Rehabilitation of North Terminal, Nordic Fisheries Inc.

ADDENDUM #2

Issued: 1/20/2023

SKETCH:

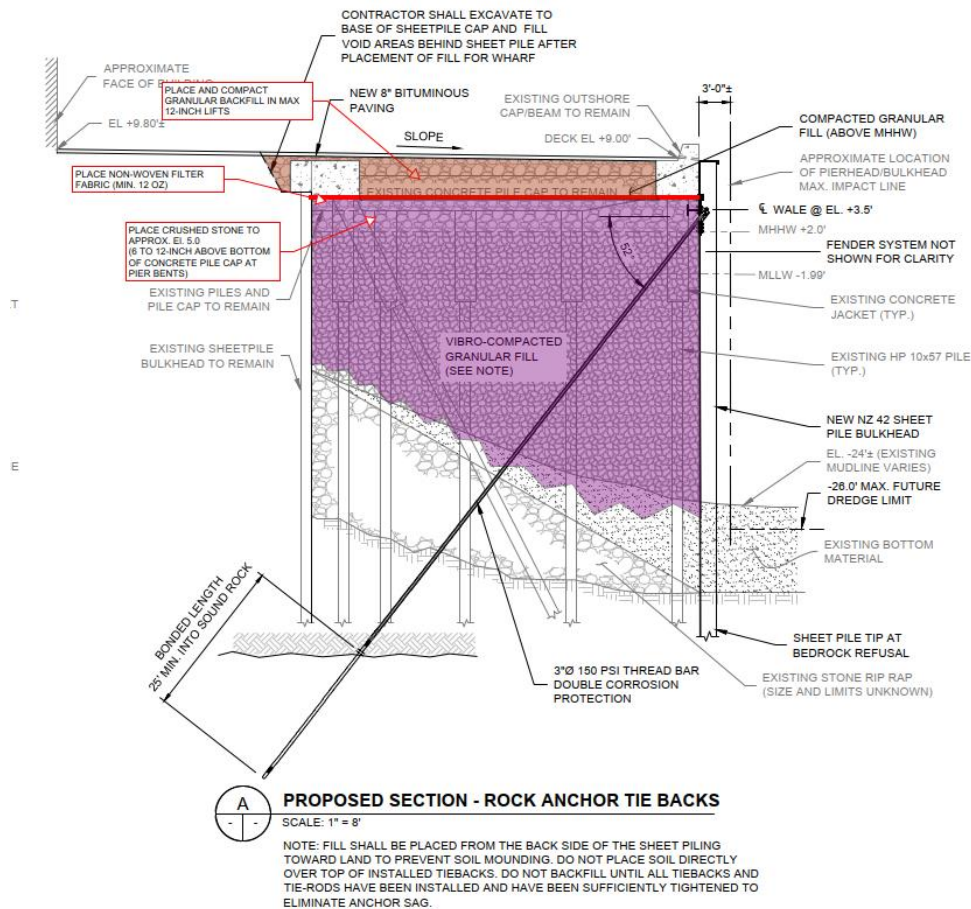
1. Regarding the Granular fill Backfill, May we use 1.5" crushed stone in lieu of granular fill?

A: Use of 1.5" crushed stone should be avoided due to uncertainty relative to ability to efficiently penetrate the material with the vibratory probe during vibro-compaction. However, ¾-inch crushed stone may be used as bulkhead backfill, as long as it can be efficiently vibro-compacted.

Due to difference in anticipated response of the crushed stone to vibro-compaction, the following procedure shall be followed when using crushed stone:

- a) Place crushed stone backfill up to above underside of existing pier bents (approx. El. 5)
- b) Vibro-compact crushed stone backfill executing the number of probe drops determined during the test program. Some settlement of the top of crushed stone is anticipated during vibro-compaction.

- c) Install 12-OZ non-woven filter fabric to cover the top of the vibro-compacted crushed stone backfill.
- d) Place approved granular fill in maximum 12-inch lifts and compact granular backfill using conventional methods (plate compactor, walk-behind roller) to 95% of the maximum dry density up to pavement section subgrade.
